Riverbend Crossing

Letter of Intent

Preliminary Plan

Add PCD File No. P189, SP187, SF1844, & SF1843

VICINITY MAP

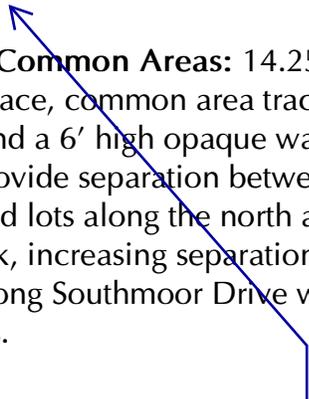
i think the property is
south of 85/87
